SERVICE BULLETIN

MITSUBISHI MOTORS

PURPOSE : CHANGE	ISSUE NO. : MSB-15EXML37-001	DATE : 2015-04-01
SUBJECT : Addition of the procedure for the replacement of the tie rod end ball joint dust cover		<DESTINATION/MODEL> (As per attached sheet 1) <M/Y> 11-16
GROUP : Gr:37(Steering)		OUTLANDER/OUTLANDER PHEV/ASX/RVR/OUTLANDER SPORT

Attached sheet 5

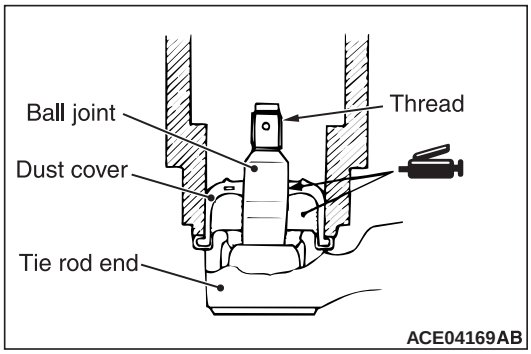
TIE ROD END BALL JOINT DUST COVER REPLACEMENT

If the dust cover is damaged accidentally during service work, replace the dust cover as follows:

1. Fill and apply the specified grease into the inside and lip of the dust cover.

NOTE: Wipe off the grease on the ball joint so that the amount of grease inside the dust cover does not exceed the total amount.

Specified grease: Multipurpose grease SAE J310, NLGI No.2 or equivalent
   Usage (Total amount):
   Inside of dust cover: 5.0 ± 1.0 g
   Lip: As required.

2. Apply the specified sealant to the dust cover mounting surface at the tie rod end.

Semi-drying sealant: ThreeBond TB1215 or equivalent
   Application amount: As required.

3. Drive in the dust cover with special tool front axle base (MB990776) until it is fully seated.

NOTE:
   - *There should be no grease on the thread of the ball joint.*
   - *There should be no clearance between the dust cover and the tie rod end.*

4. Check the dust cover for cracks or damage by pushing it with your finger.

Attached sheet 6

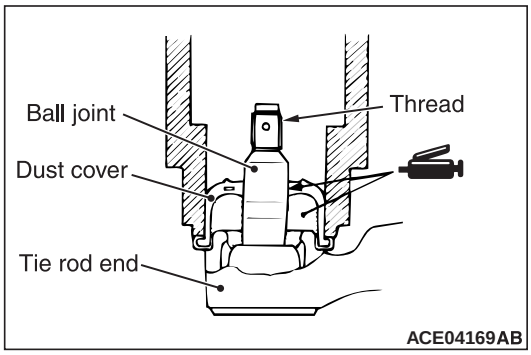
TIE ROD END BALL JOINT DUST COVER REPLACEMENT

If the dust cover is damaged accidentally during service work, replace the dust cover as follows:

1. Fill and apply the specified grease into the inside and lip of the dust cover.

NOTE: Wipe off the grease on the ball joint so that the amount of grease inside the dust cover does not exceed the total amount.

Specified grease: Multipurpose grease SAE J310, NLGI No.2 or equivalent
   Usage (Total amount):
   Inside of dust cover: 5.0 ± 1.0 g (0.18 ± 0.04 oz)
   Lip: As required.

2. Apply the specified sealant to the dust cover mounting surface at the tie rod end.

Semi-drying sealant: ThreeBond TB1215 or equivalent
   Application amount: As required.

3. Drive in the dust cover with special tool front axle base (MB990776) until it is fully seated.

NOTE:
   - *There should be no grease on the thread of the ball joint.*
   - *There should be no clearance between the dust cover and the tie rod end.*

4. Check the dust cover for cracks or damage by pushing it with your finger.
